# MIAMI BEACH

### Staff Report & Recommendation

SUBJECT: **PB 18-0201 1685 Washington Avenue.**

The applicant, Sobe Center, LLC, is requesting Conditional Use approval for the construction of a new 8-story mixed-use development exceeding 50,000 square feet including a mechanical parking garage pursuant to Section 118, Article IV and Section 130, Article II of the City Code.

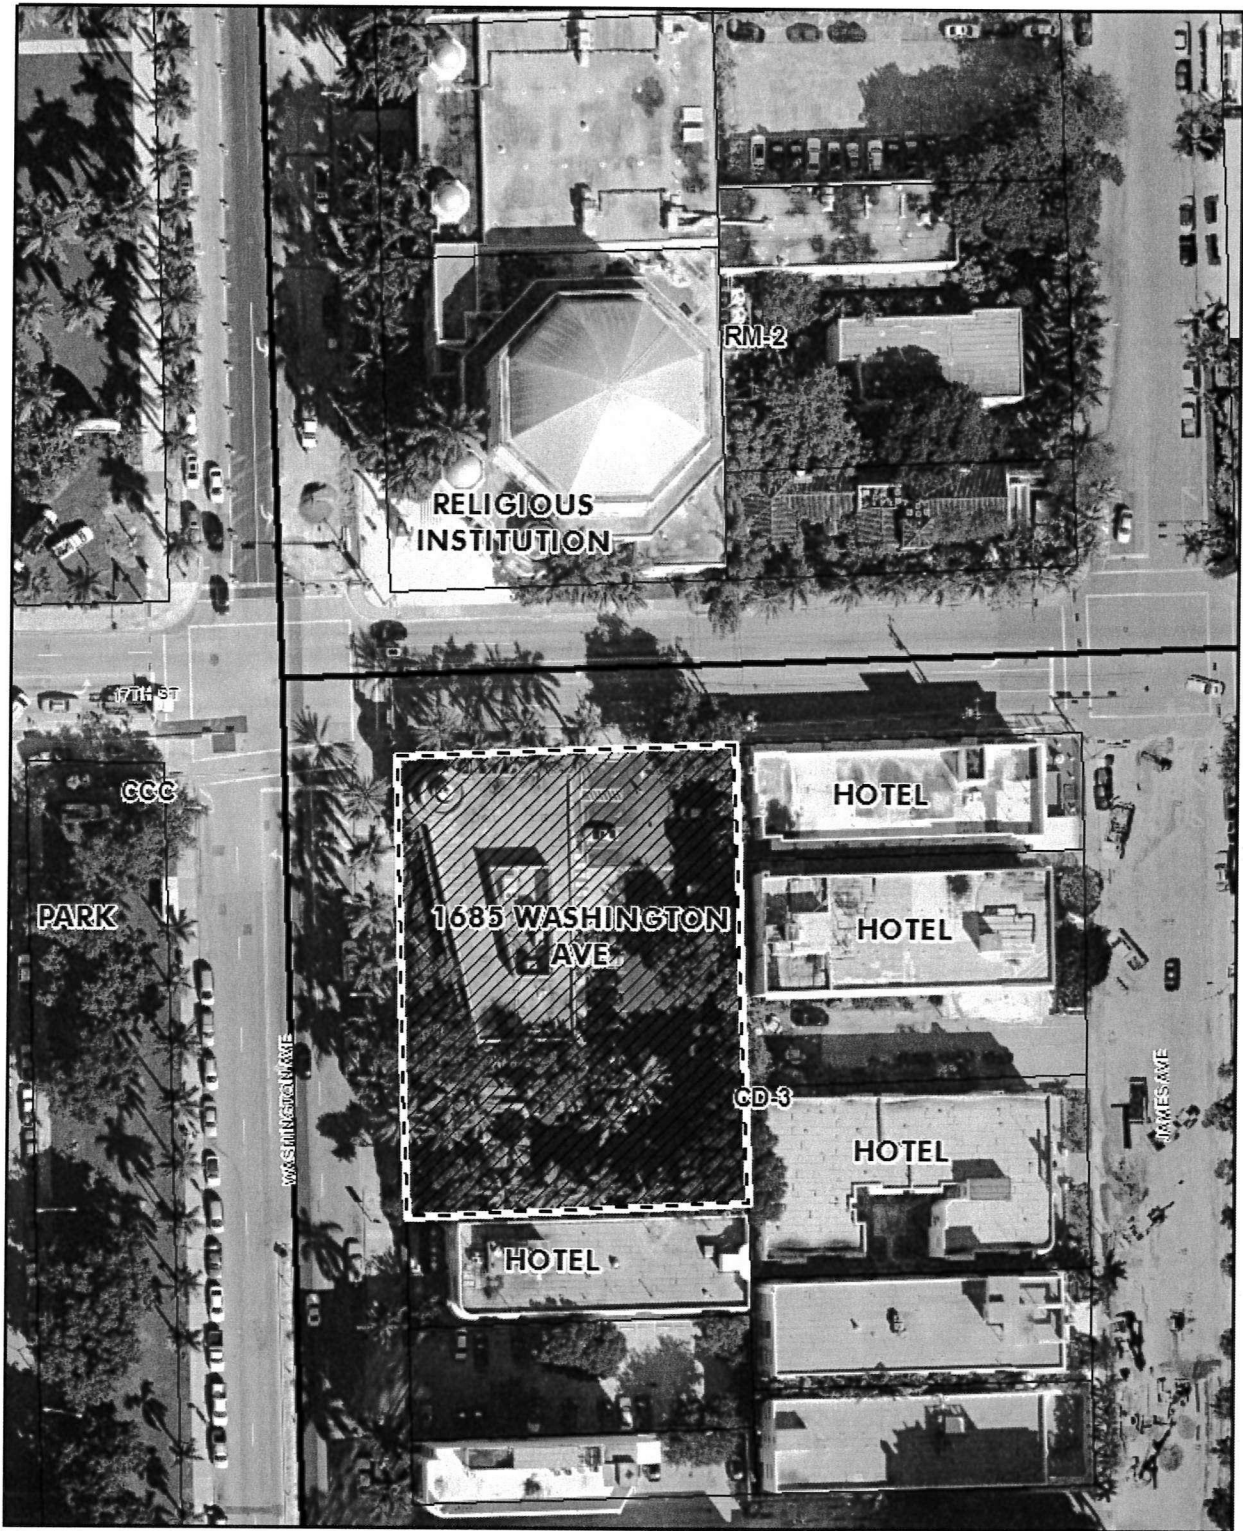
The parking garage on the second floor has minimal openings to the hotel building on the south, however staff is concerned that the proposed screen on the second level along the east façade is too open and potentially this will allow sound and light transmission from the cars using the mechanical lifts, negatively affecting the hotels located on the east side of the property. Staff is recommending that a floor to ceiling wall shall be incorporated behind the proposed screen on the

east side, where the mechanical lifts spaces are proposed.

- a. At the second level on the east side, a floor to ceiling wall shall be incorporated behind the proposed screen where the mechanical lifts spaces are proposed, subject to the review and approval of staff.
